U N I V E R S I T Y O F SOUTH CAROLINA

AMENDMENT NO. 1

SUBJECT: USC-IFB-2290-LW
Bat Removal, Exclusion and Clean-up at USC Hamilton College

DATE: August 8, 2012

BARNWELL 018
2ND FLOOR

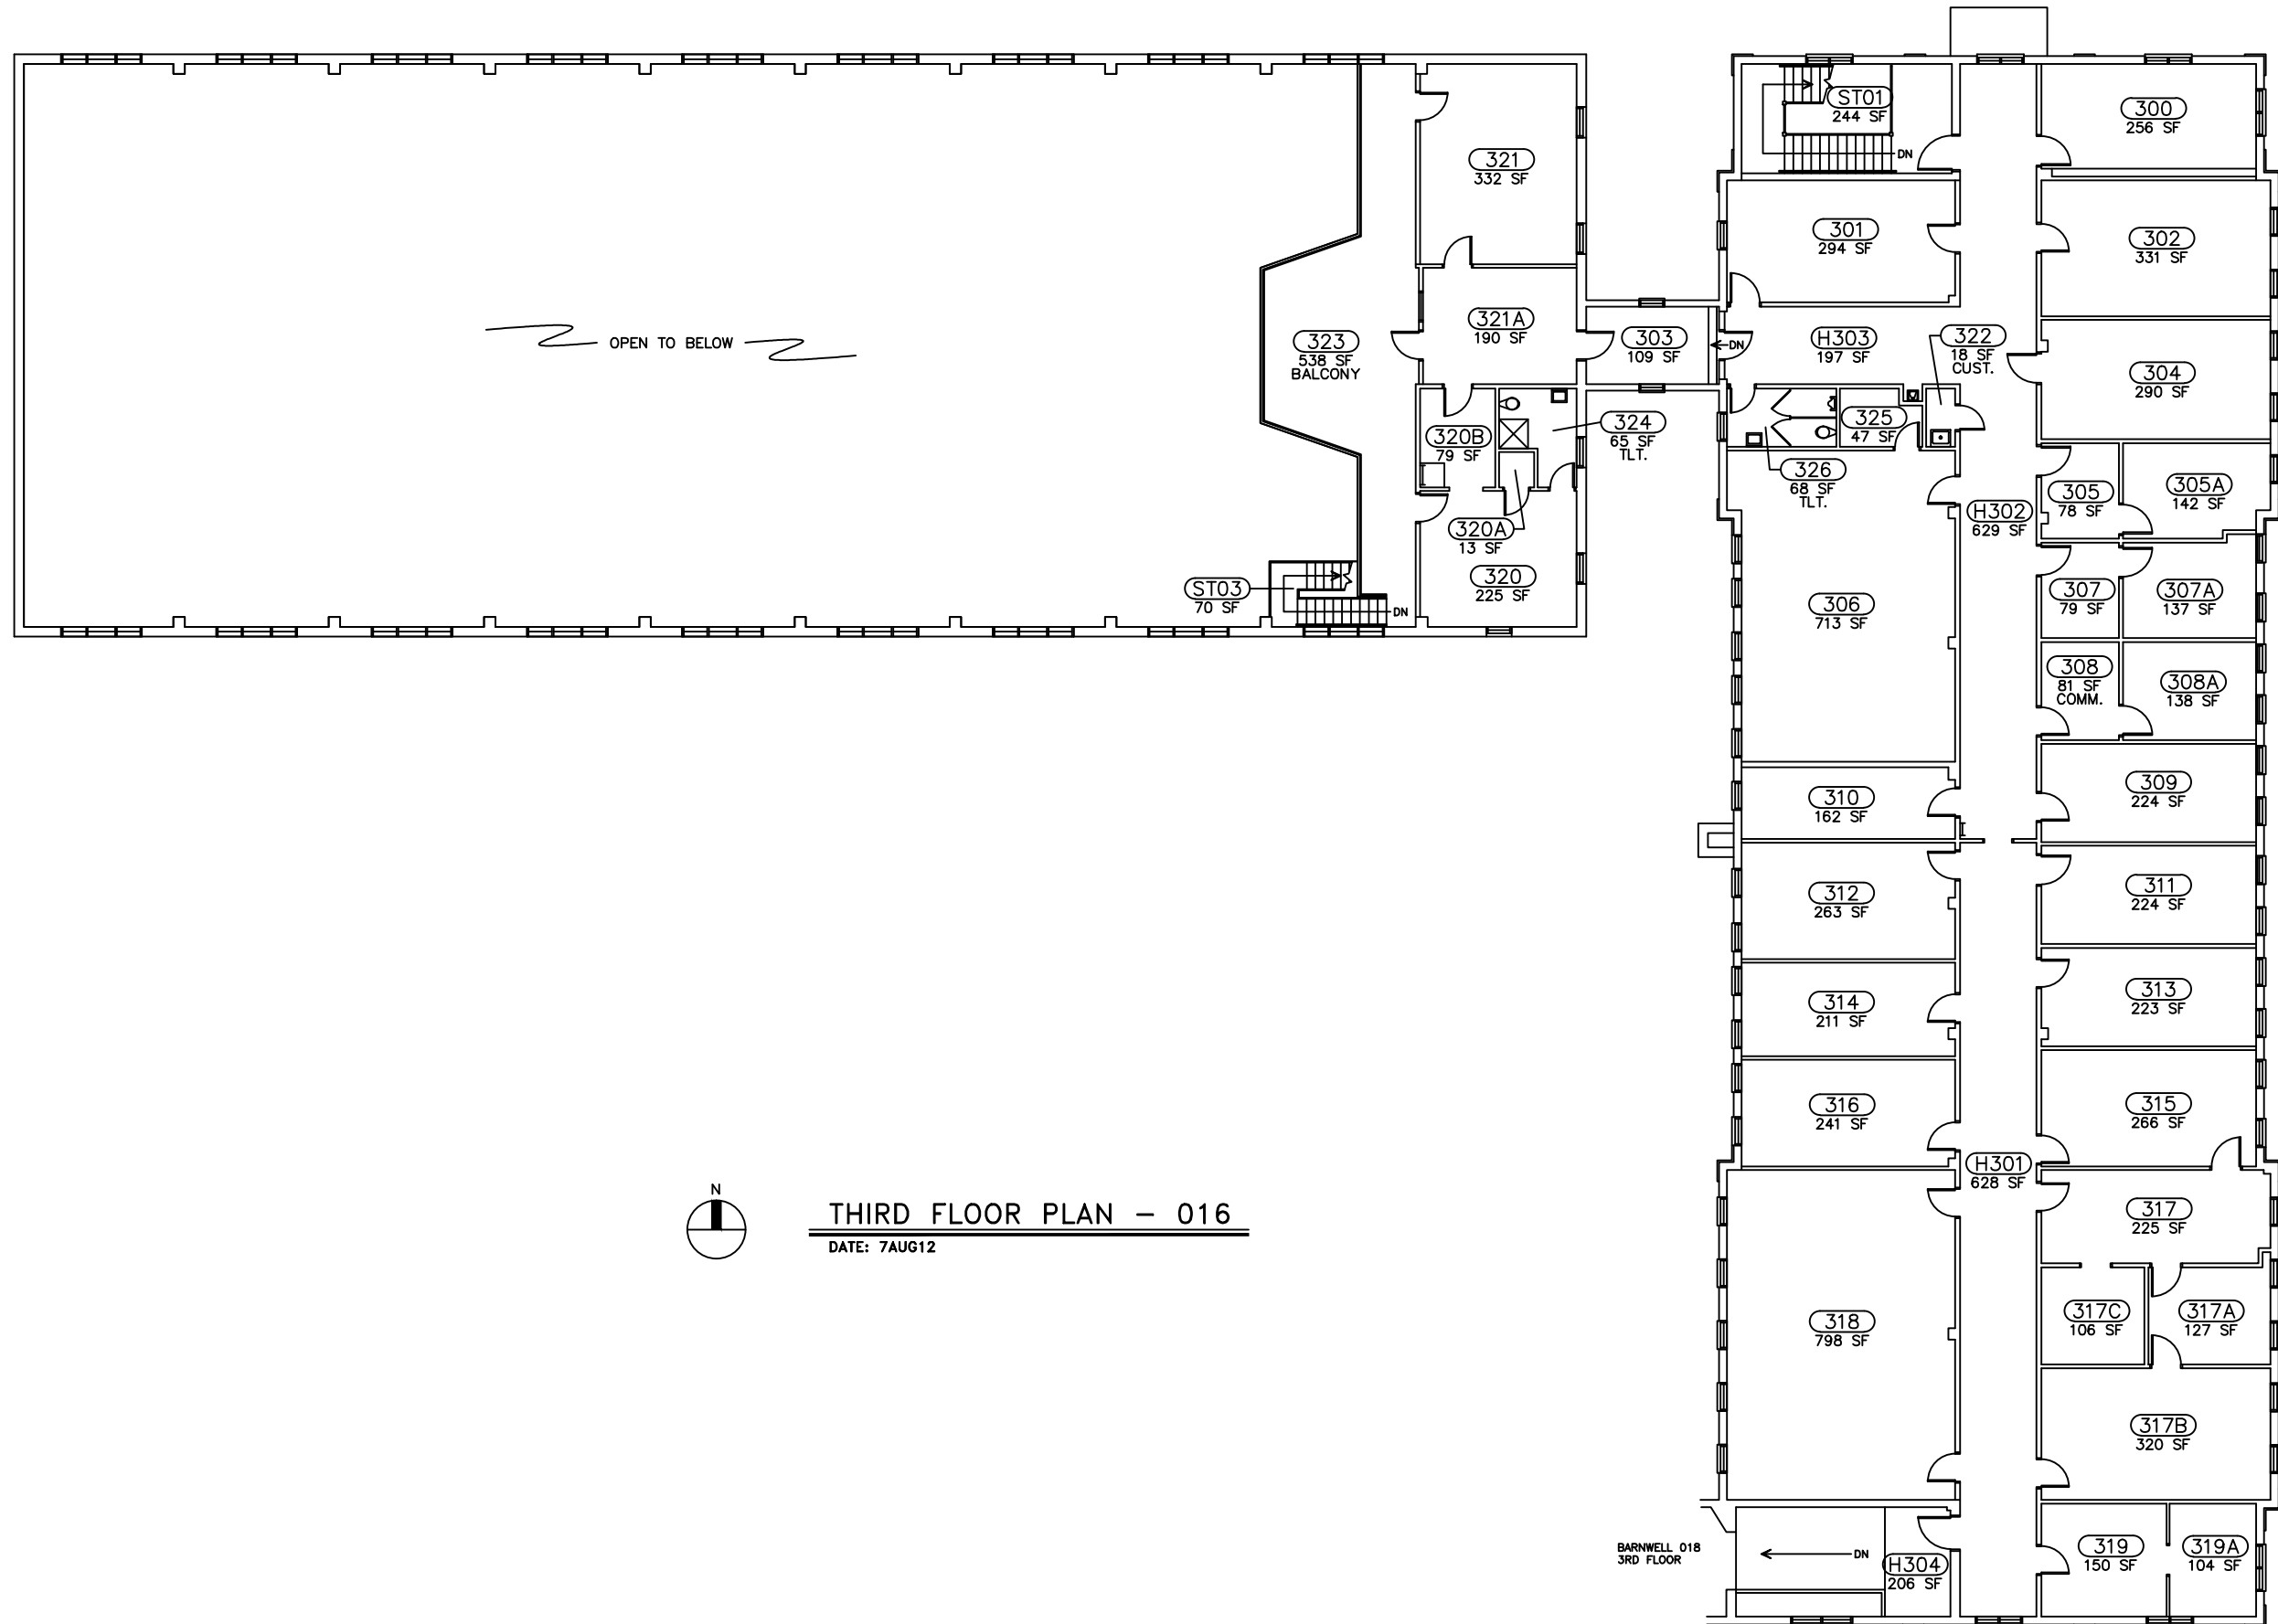
Will you supply a diagram or plan for the building?

PDF copies of the current square footage floor plans for Hamilton College (Building #016) as on file are attached for your use.
